## TECHNICAL BULLETIN

FAM-A-0059-A

### Change of External Appearance of the FX3U Main Modules

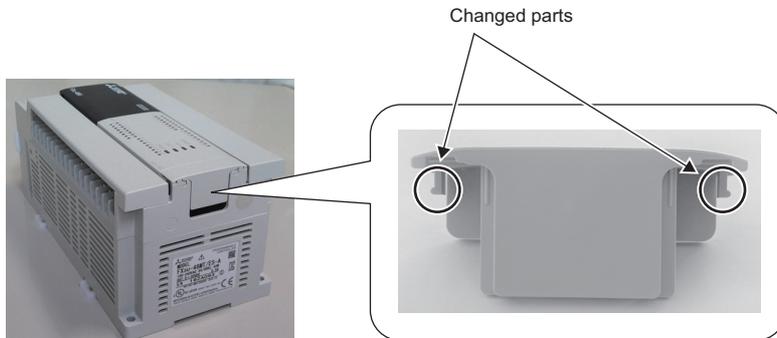
This technical bulletin informs you that the external appearance of the MELSEC-F series FX3U main modules will be changed.

The shape of the connector cover for extension devices will be changed as follows.

To improve the ease of installation.
